13 May 2016

Our Ref: P15-190

**RE: MODIFICATION REQUEST FOR SHEPHERDS BAY CONCEPT PLAN MP09_0216
MOD2 - RESPONSE TO SUBMISSIONS**

Figure 3: Extract of shadow analysis at 3pm, June 21 (source: Cox Richardson/Kennedy Associates)

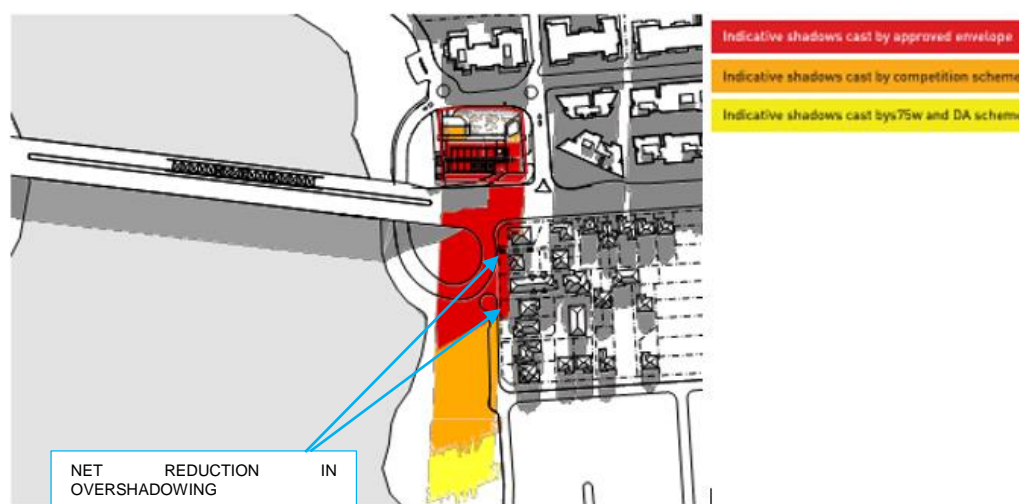
In addition to negligible visual impacts, the additional tower height is also justified on the basis it provides for negligible additional overshadowing impacts on the public domain. Arguably, public domain overshadowing is improved given overshadowing is consolidated into a narrower geographic area, as opposed to a wider geographic area, as is the case in the concept approved envelope.

Of more importance is that the proposal's overshadowing results in a net reduction of overshadowing to existing private residences, compared to the envelope approved in MP09_216. The net reduction occurs at approximately 2 - 3pm, to the front yards of those dwellings on the eastern side of Church Street (specifically 13 - 15 Waterview Street, Putney). Again, this is largely a result of a slender and narrower building envelope. A complete set of overshadowing diagrams demonstrating this outcome is provided at **Appendix D**. An extract of such plans is provided below.
